19PBE

Safety Recall - Back of Sleeper Reflective Conspicuity Tape Location

Subject: Safety Recall 19PBE – Back of Sleeper Reflective Conspicuity Tape Location
NHTSA 19V733
EXPIRATION DATE: NONE

Figure 1

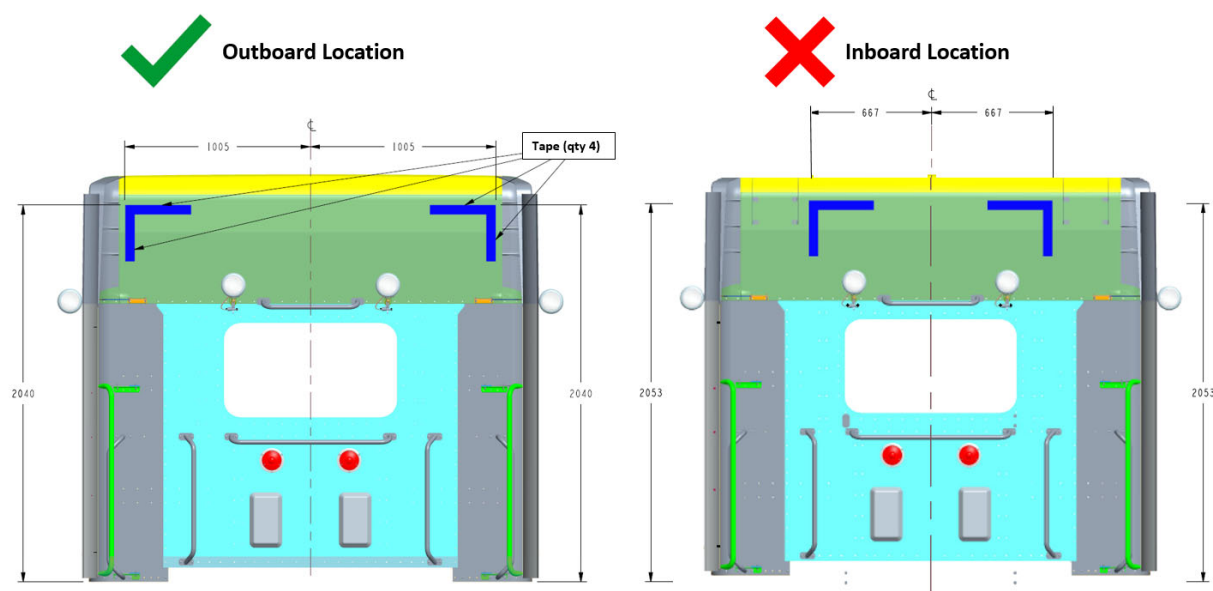
Peterbilt Motors Company has determined that a regulatory non-compliance, may exist in certain model 579 vehicles manufactured between 8/26/2019 and 9/12/2019. On certain trucks, the reflective conspicuity tape on the back wall of the sleeper box was installed in incorrect locations. FMVSS 108 Section S8 2.4.2 regulations require the conspicuity tape to be placed in specific areas. A truck that does not have properly placed conspicuity tape may be less visible to others and could create an increased risk of a crash. Vehicles operating without a trailer may be cited for incorrect tape location and fail an annual truck inspection.

1. Refer to Figure 1 and inspect the location of the Reflective Conspicuity Tape.
2. If the tape is located in the inboard location, continue to the next step. Removal of the tape in the inboard location is not required. If the tape is removed, use an adhesive cleaner that is appropriate for use on painted surfaces to remove the tape residue.
3. Clean the new installation surface and install the new tape in the outboard location as shown in Figure 1.
